William States Lee III Nuclear Station - Docket Nos. 52-018 and 52-019 AP1000 Combined License Application for the William States Lee III

Partial Response to Request for Additional Information

(RAI No. 826)

Ltr # WLG2008.12-06

FSAR Figure 2.4.12-208

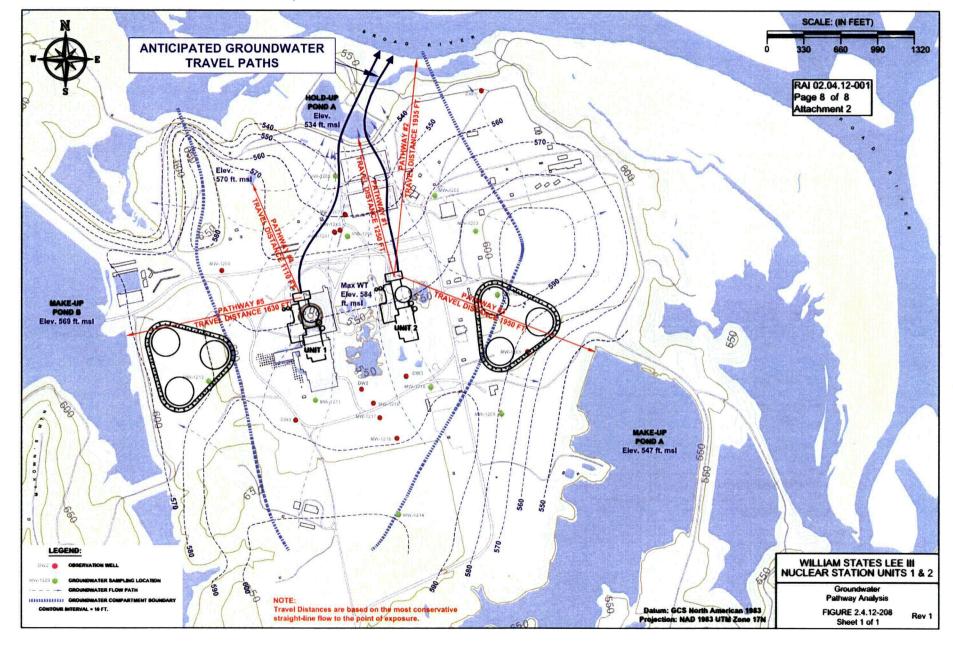
Each pathway was evaluated based on hydraulic conductivity (Subsection 2.4.12.2.4.2), effective porosity (Subsection 2.4.12.2.4.1) and hydraulic gradients (derived from Figure 2.4.12-204, Sheet 8). Additional information on the development of these and other soil characteristics (i.e. whether they were calculated or site specific) can be found in FSAR RAIs 2.4.12-005 (this letter) and FSAR RAIs 02.04.13-010, 02.04.13-012, and 02.04.13-005 (submitted under separate cover).

These pathways are represented on Figure 2.4.12-208. The results of the analysis identified the conservative flow path for a postulated release to be from the Unit 2 radwaste storage tank to the Broad River (Pathway 2, Figure 2.4.12-205, Sheet 3).

2.4.12-208 Groundwater Pathway Analysis

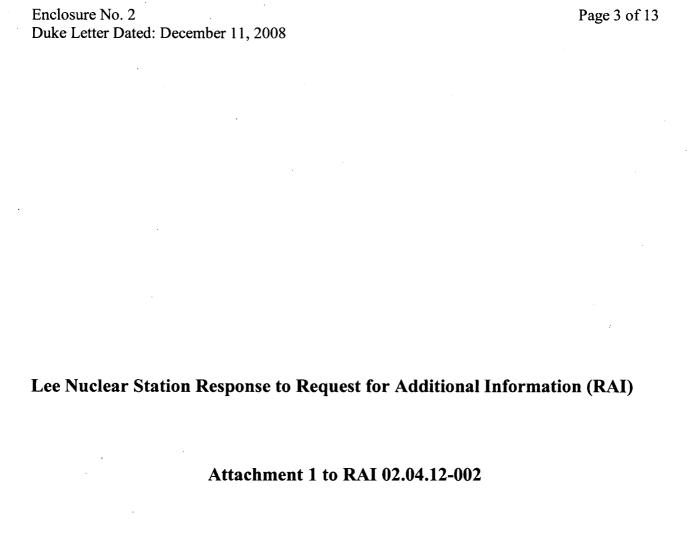
In Section 2.4.12.3.3, quantify the distribution of well depths in the region. If there are any wells deeper than 150 ft deep, provide the number and whether any are within a mile of the plant boundary. If the modern trend is for people to abandon wells and convert over to public water from Draytonville (or elsewhere), provide a reference.

Regarding well depths, only three of the 50 wells identified in the Cherokee Nuclear Station ER¹ were reported to be completed to depths of 150 feet or greater. Those wells are identified on the attached figure (Attachment 3). A review of data² provided by the South Carolina Department of Health and Environmental Control identified 22 wells completed since 1985 to depths greater than 150 feet within a 1-mile radius of the Lee Nuclear Site property boundary (Attachment 3).

The Cherokee Nuclear Station Construction Permit ER identified 50 domestic water wells and provided construction details for these wells, including well diameter, well depth, and depth to water (see Table 2.4.1-212 and Figure 2.4.1-212). Only three of these 50 wells have total depths of 150 ft. or greater. Since 1985, 22 wells have been installed within a 1-mi. radius of the Lee Nuclear Site property boundary and to a depth greater than 150 ft. (Reference 261). However, according to information provided by the Draytonville Water District, public water supply lines were installed in the late 1990s and continue to be added in the area surrounding the Lee Nuclear Site. As of 2007, since public water supply lines were installed in the area, approximately 55 percent of residents within a 2-mi. radius of the reactor buildings have converted from self-supplied groundwater systems to public water supplies. Furthermore, with the addition of water-supply lines planned for completion in 2009, the public water is expected to be available to approximately 83 percent of those residents within the 2-mi. radius of the plant. The projected use of self-supplied groundwater systems is expected to continue to decline as public water supply lines are built into rural areas and residents increase their dependence on the public water supply.

Lee Nuclear Site Precipitation and Water Table Graphs

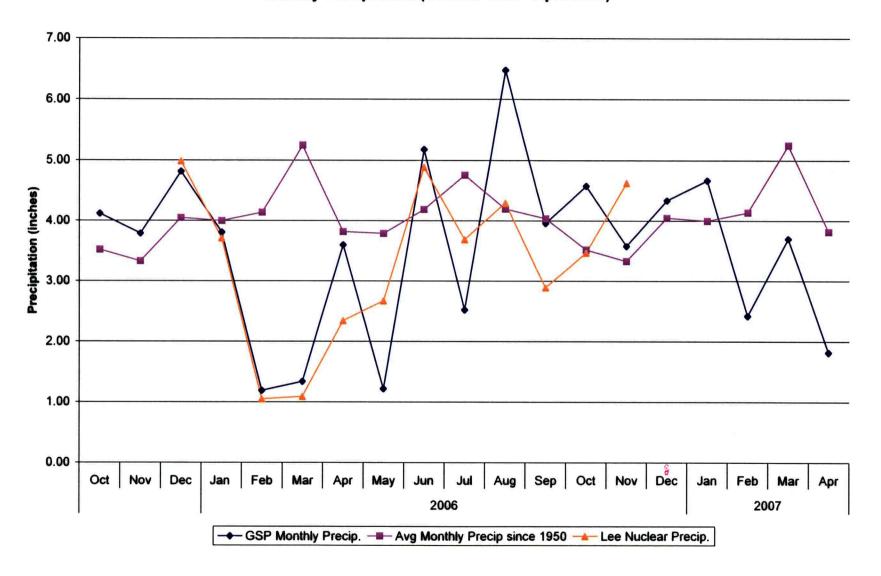
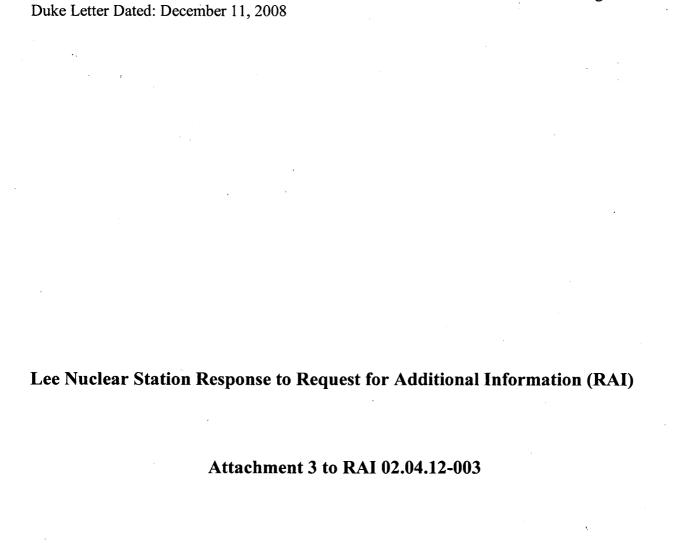
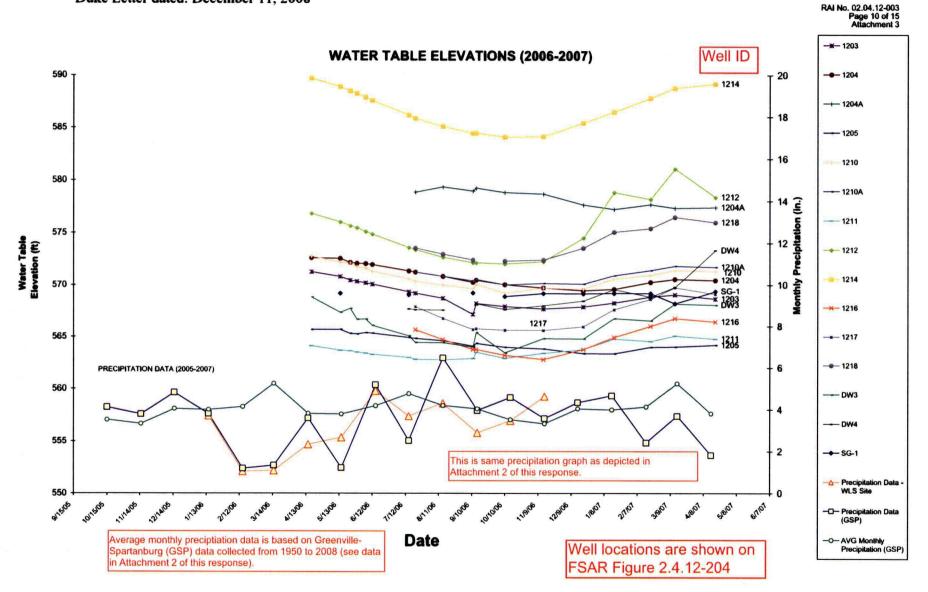
One of the goals of the one-year monitoring period portrayed by Figure 2.4.12-203 is to demonstrate how groundwater height and flow direction responds to precipitation spatially and temporally. Provide monthly precipitation amounts with the figure (i.e., for April 2006 through April 2007). Explain how the precipitation received during this period related to normal monthly amounts. In addition, characterize the precipitation conditions for the 7 months (i.e., Oct 2005 to April 2006) previous to the monitoring period to provide context to the start of the observation period.

The Lee Nuclear Site meteorological data (average monthly precipitation amounts) were available for the months of December 2005 through November 2006. These site-specific data were compared with National Oceanic and Atmospheric Administration (NOAA) data (Attachment 4) collected at the Greenville-Spartanburg (GSP) Airport (approximately 45 miles west of the Lee Nuclear Site) for the period October 2005 through April 2007. The correlation between precipitation data obtained from GSP and the Lee Nuclear Site was good, as shown on the attached figure (Attachment 2).

Additionally, using the GSP precipitation data from 1950 to 2008, average monthly values were calculated (Attachment 2, Page 1) to determine "normal" monthly precipitation to evaluate whether the observed average monthly precipitation at the Lee Nuclear Site was relatively wet or dry during the investigation; "normal" in the remainder of this response refers to those average monthly values. The graph presented on Attachment 2, Page 2, shows the monthly precipitation data observed at the Lee Nuclear Site and GSP. It also shows the "normal" average monthly data described above. From October 2005 to January 2006, above normal precipitation occurred at the Lee Nuclear Site. From January 2006 to around October 2006, Lee Nuclear Site conditions were typically drier than normal. November 2006 was wetter than normal. From December 2006 through April 2007, the Lee Nuclear Site had around normal to below normal precipitation amounts.

A comparison was made between the observed monthly precipitation for the period April 2006 through April 2007 at the Lee Nuclear Site and GSP versus the groundwater levels observed in monitoring wells. The comparison is presented on the attached figure (Attachment 3). Along with other factors, precipitation and evapotranspiration play the major role in determining the groundwater behavior. The annual distribution of the precipitation is fairly even throughout the year as shown in Attachment 2 and 3. Although precipitation is relatively evenly distributed throughout the year, the water table fluctuates noticeably, rising during the winter to an annual high in April- May and declining through summer and fall, reaching their lowest levels in

Figure - Locations of Springs and Seeps

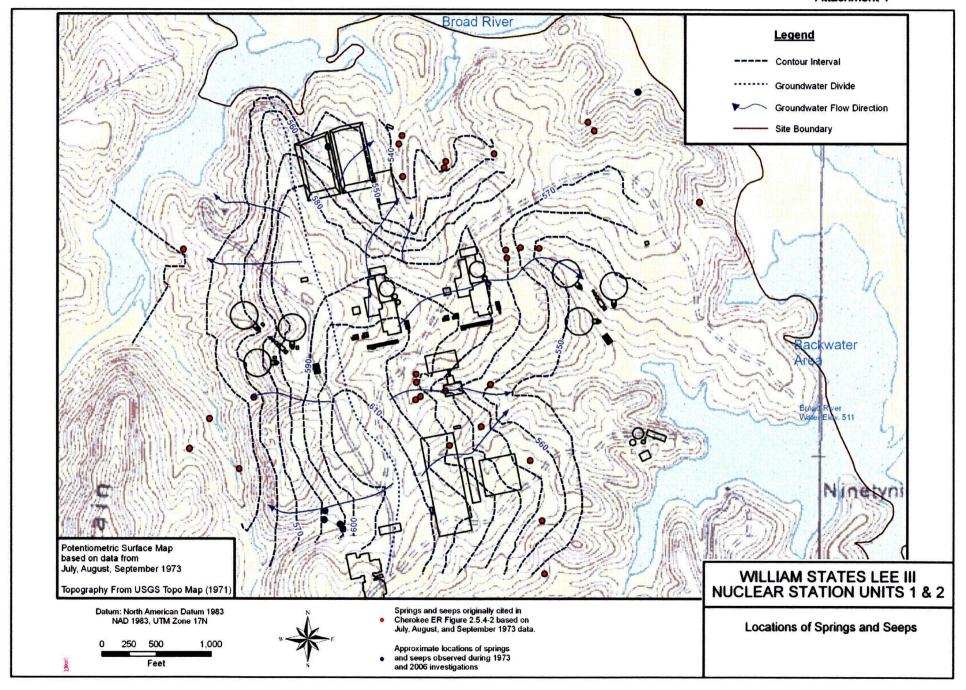
Update the Figure 2.4.12-201 to include an outline of the Lee Nuclear Island (for reference purposes) and the locations of springs and seeps. Differentiate between the springs and seeps that existed before the original Cherokee construction and the current springs and seeps.

Duke Energy has prepared a figure showing the locations of current springs and seeps and those observed during the original Cherokee construction. The power block is included on this figure for reference, overlaid on the existing FSAR Figure 2.4.12-201. This figure is provided for NRC's use and will not result in a change to the Final Safety Analysis Report.

K vs Depth for 1970s and 2006 Data Sets

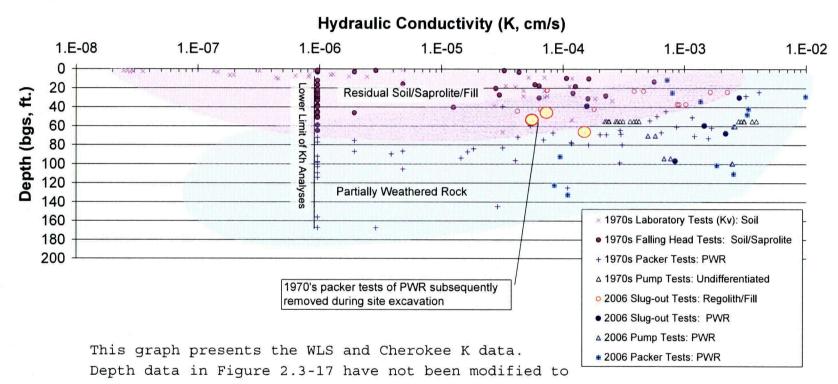
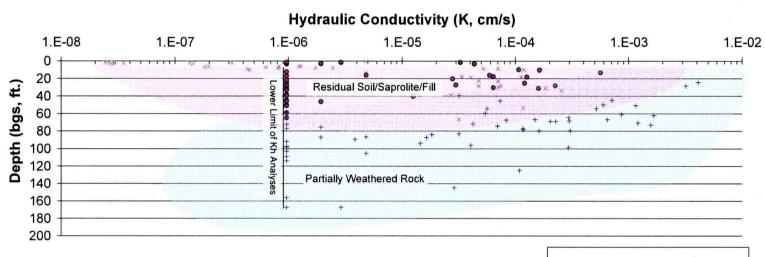
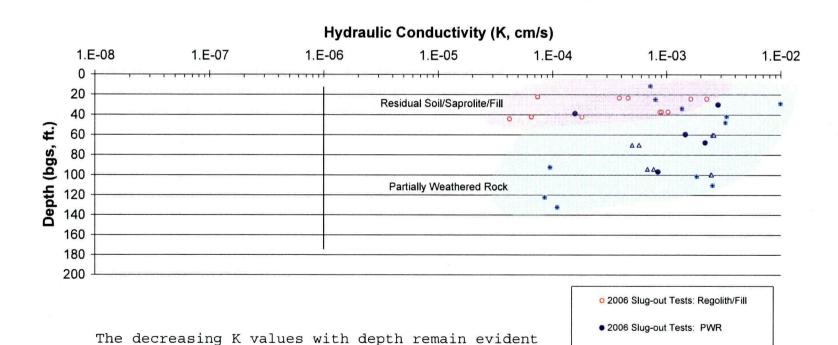
FSAR Figure 2.4.12-207 displays conductivity data as a function of depth. The figure combines data from two separate time periods (1970s and 2006) that have distinctly different surface elevations (and thus different depths) because of the geoengineering of the site. Describe how the depth data have been adjusted or rectified to reflect the correct elevation in the figure for the conductivity data points. Explain any added "noise" and "bias" to the K versus depth comparison caused by the depth differences.

The data from 1970 and 2006 were not modified to adjust for changes between pre-Cherokee construction era elevations and the current elevations, but it is recognized that the 2006 data and 1970s data do not share a constant datum (i.e., 1970s surface grade elevations do not equal the 2006 surface grade elevations). The upper ranges of 2006 hydraulic conductivity (K) data are consistent with the upper ranges of 1970s K values relative to lithology (e.g., higher values of K values determined in 2006 for partially weathered rock (PWR) were generally consistent with PWR K values determined in the 1970s and are in range of 1E-03 to 1E-02). While the depths of the samples collected in areas of cut and fill have changed, the soil and rock characteristics have not. Therefore, the depth changes add "noise" to Figure 2.4.12-207. Separating the 1970s and 2006 data sets allowed independent comparisons of K versus depth (Attachment 2). Both comparisons showed the hydraulic conductivities decrease with depth as PWR transitions to continuous rock.

Potential "bias" in the 2006 K data may exist because one goal of the groundwater investigation was to identify preferential flow paths. Using Cherokee investigation data, an attempt was made to explore for areas with relatively higher Ks than those in other areas of the site. This exploration approach would potentially bias the 2006 results to higher K values than the 1970s K values. A revision of the Final Safety Analysis Report Subsection 2.4.12.2.4.2 text is provided as Attachment 1 to clarify the discussion of hydraulic conductivity. The identified changes will be incorporated in a future revision of the Final Safety Analysis Report.

Replacement for Figure 2.4.12-205 (Sheets 2, 3, and 4 of 4)

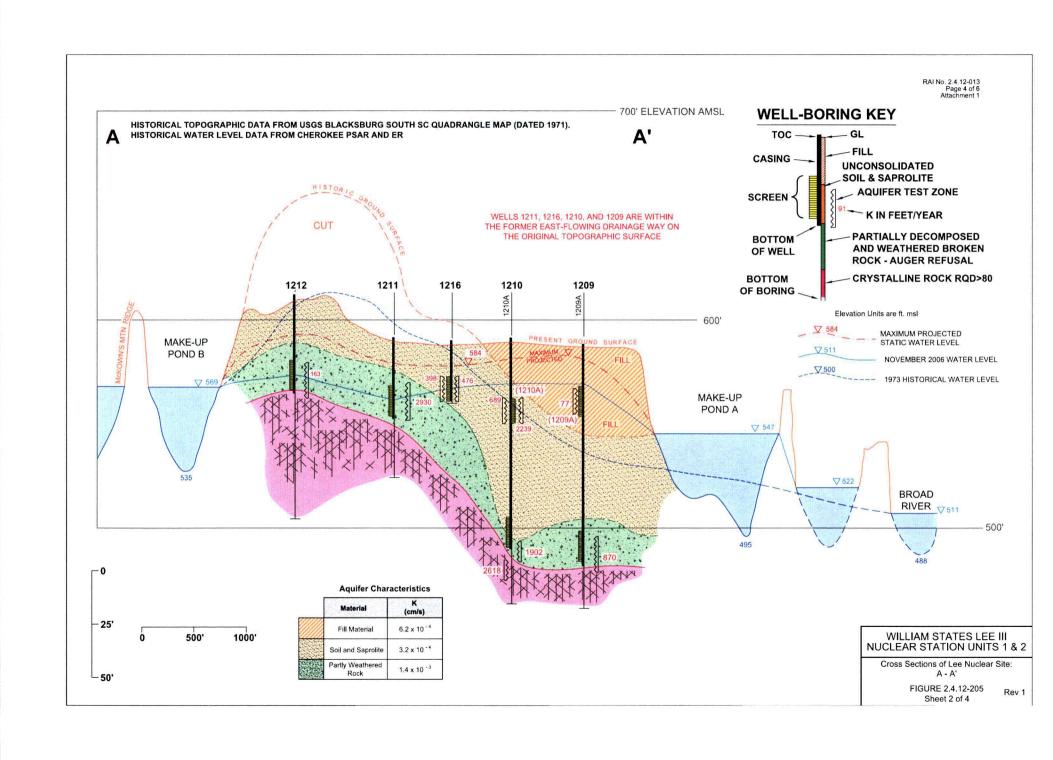
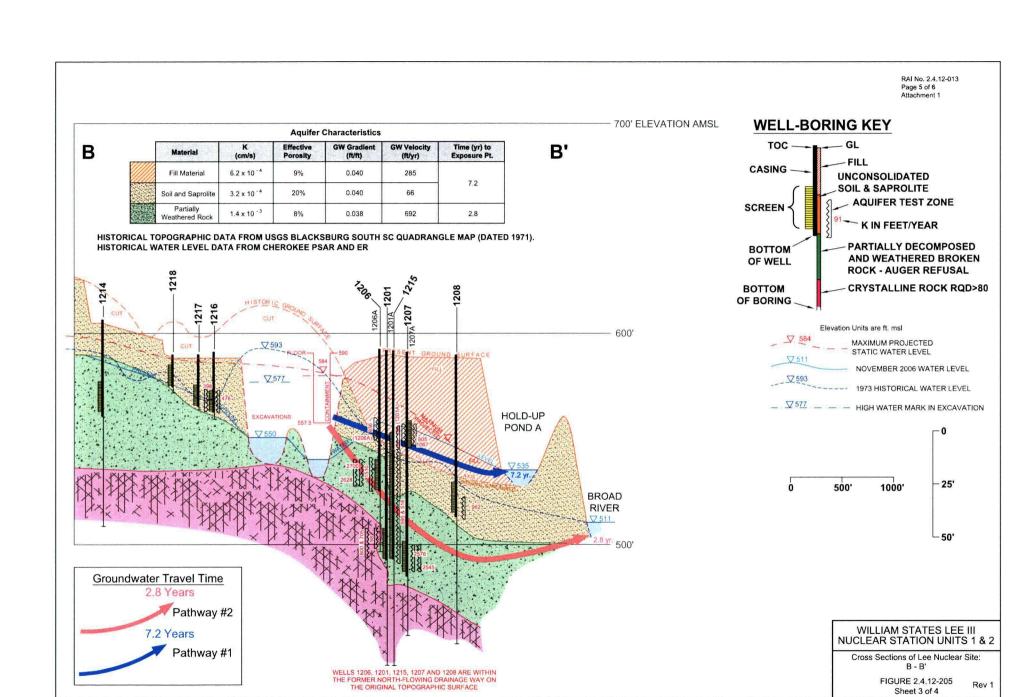
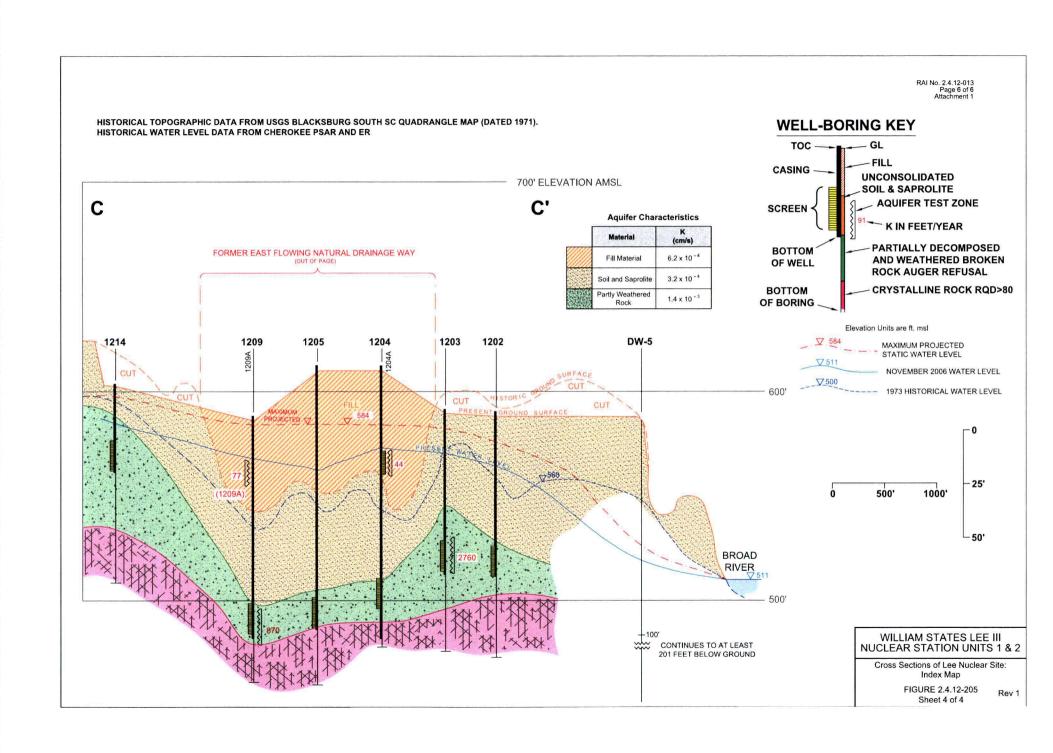
Figure 2.4.12-205 shows estimates of groundwater gradients (0.034 and 0.036) that are slightly different than values (0.033 and 0.035) calculated from the reported measurements (i.e., max groundwater elevation 579 ft; holdup pond A 535 ft; river 511 ft; distance to holdup pond A 1340 ft; distance to river 1935 ft). Confirm which values are correct.

The basis of the estimated groundwater gradients shown on Figure 2.4.12-205 (Sheet 3 of 4) changed following the submittal of the FSAR document. The estimated maximum groundwater elevation increased from 579 to 584 ft msl. The 579 ft msl elevation was based upon the surveyed elevation of the observed high water level mark (578.72 ft msl) on the Cherokee power block structures. The 584 ft msl is derived assuming water levels would be unlikely to exceed 5 ft. above the observed high water mark. In addition, flowpath distances were revised to reflect the shortest distance between the edges of the respective water bodies, rather than the respective center points. The resultant groundwater gradients allow for more conservative calculations of other hydraulic properties, such as groundwater travel time. The correct values are as follows:

The FSAR revisions to Subsection 2.4.12.3.2 in the response to RAI 02.04.12-001 (this letter), Subsection 2.4.12.5 in the response to RAI 02.04-006 (this letter), and Table 2.4.12-204 in the response to RAI 02.04.12-004 (this letter) reflect the corrected groundwater gradients. Attachment 1 contains a replacement for Figure 2.4.12-205 (Sheets 2, 3, and 4).
